49 Sixth St - AHO Initial Report		
Comment topic	Comments	Response
Zoning/Planning Comments	<ul style="list-style-type: none">• Provide a clear description of all existing trees on the site, including those in the courtyard. Show what trees are being preserved, what trees are being removed, and what trees are being added.	Done, please refer to slide #8 and #9
	<ul style="list-style-type: none">• You note that street trees are not within the project budget. Provide more information about the tradeoffs to the project of including street trees.	Street trees would be an added cost in an affordable housing budget, funded in a part by CCD, that is not able to afford added costs.
	<ul style="list-style-type: none">• How many long-term bicycle parking spaces are you providing? There were inconsistencies between the dimensional form and the application narrative in your prior submission.	48 total spaces (amount that would be required by zoning if it applied). 4 of these 48 are sized for tandems/trailers as would be required by zoning.

49 Sixth Street

Advisory Design Consultation with Cambridge Planning Board

- Converting Sacred Heart rectory, school, and convent into 46 affordable apartm

② UNITS 23, 24 - ANNEX
3/64" = 1'-0"

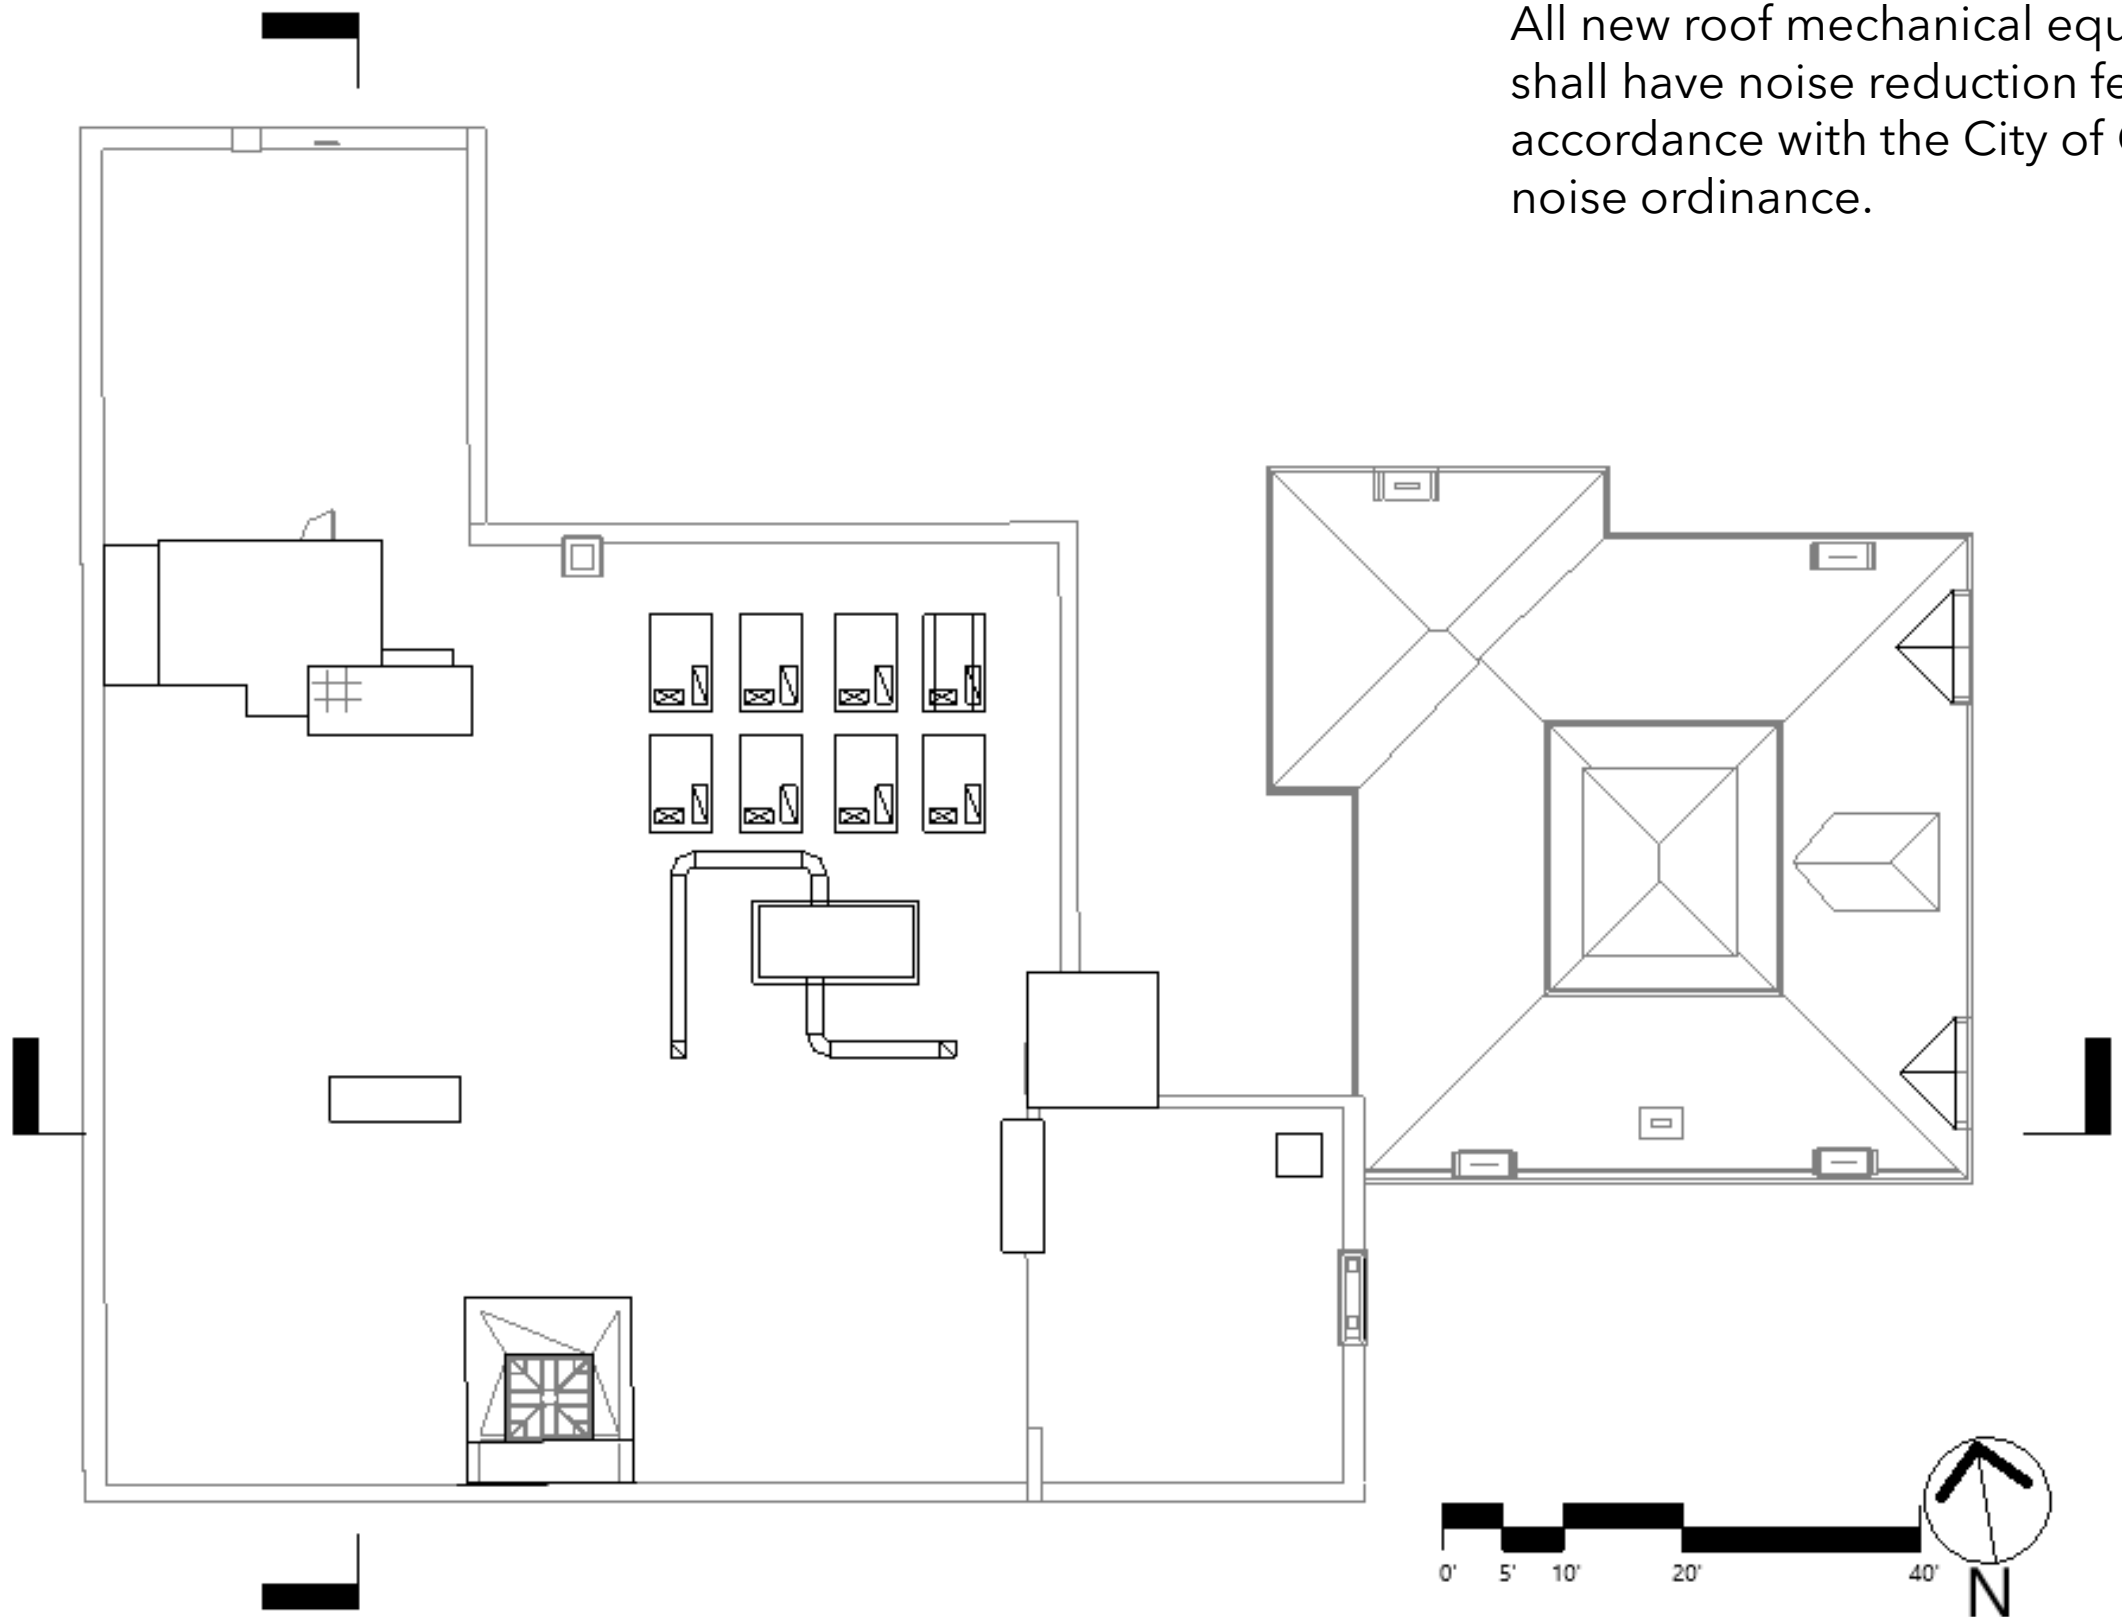
- Are all of the enlarged unit plans floated off to the right of the building plan on intermediate levels? If so, it would be helpful to consistently indicate their floor levels.

- But it looks like some of the enlarged unit plans are just to show more detail, not on intermediate

levels. If so, it would be clearer if these were separated from the intermediate level unit plans.	Done, please refer to slides # 16-20
	- It would be easier to read the plans if they were bigger on the page, which could be done by moving the "Building Program Key". And it would be helpful if the unit numbers were easier to read.

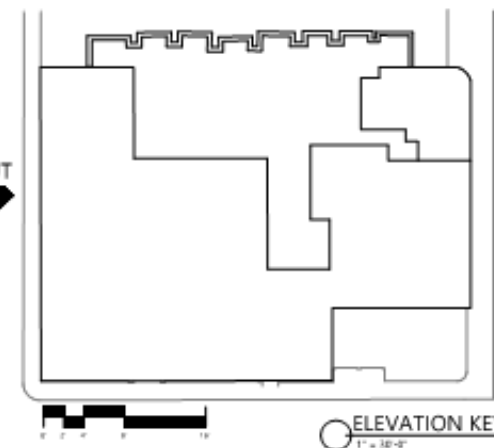
- Coordinate the section keys with the building sections	
	- Include north arrows.	
	• Page 15 roof plan: Where will HVAC equipment for the units in the Rectory be located? Will all the HVAC units really be in the NE corner of the school, or will some of them be more directly over the units they serve? Add notes to the plan, mech equipment and other features.	All HVAC equipment will be located on the given roof area to serve all project components. M&E Design is under progress based on this schematic equipment location. HVAC equipment will be visually screened and shall have noise reduction features in accordance with the City of Cambridge noise ordinance.

All new roof mechanical equipment shall have noise reduction features in accordance with the City of Cambridge noise ordinance.
